Detailed Site Plan Alternative Compliance Parliament Place

DSP-20024
AC-20011

STAFF REPORT

SUBJECT: Detailed Site Plan DSP-20024
Type 2 Tree Conservation Plan TCP2-033-2020
Alternative Compliance AC-20011
Parliament Place

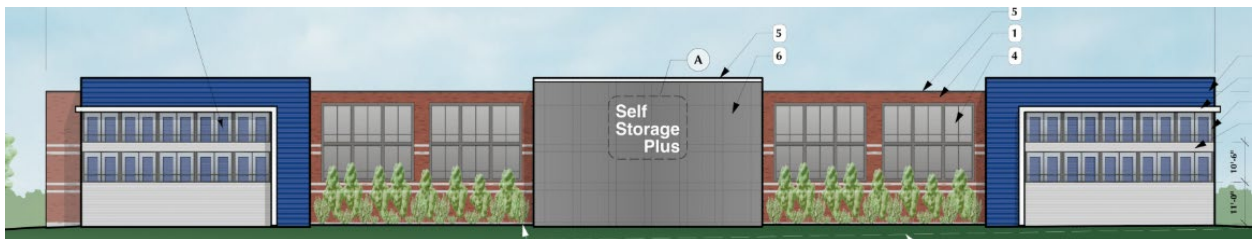
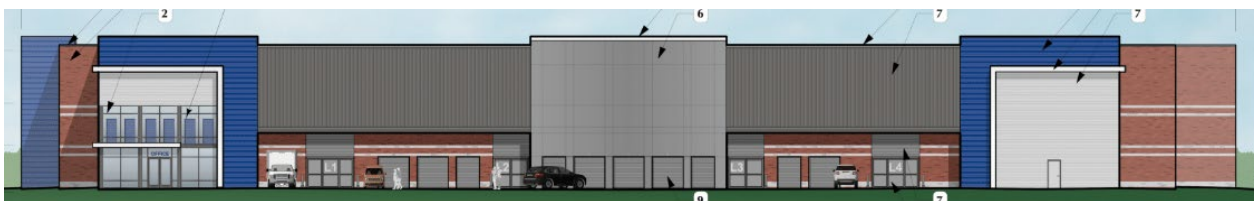
The office will be located on the southeast corner of the building, at the entrance to the site, and is distinguished by two stories of storefront fenestration, framed with the blue metal panels and white trim. Above the entrance will be a decorative display showing blue storage doors. It is important to note that these storage doors, as well as storage doors shown on other exterior elevations, are purely decorative, will not function as individual storage units, and will not be accessible by customers. This is a typical feature with many consolidated storage facilities developed throughout the County. The entrance to the interior storage units will be from four locations along the northeast elevation, identified numerically on the storefront fenestration. In addition, 10 individual units can be accessed directly from the parking and loading area, and also along the northeast elevation. These entrances are not visible from any street.

The applicant proposes two building-mounted signs; one on the southwest elevation and one on the northwest elevation. Each sign will be 107.5 square feet with individual, internally lit, white lettering providing the text “Self Storage Plus” in a stacked, vertical pattern. Signage details are provided with this application showing conformance to the Prince George’s County Zoning Ordinance requirements.

The architectural plans provided with the application show the proposed building to be 36 feet in height.
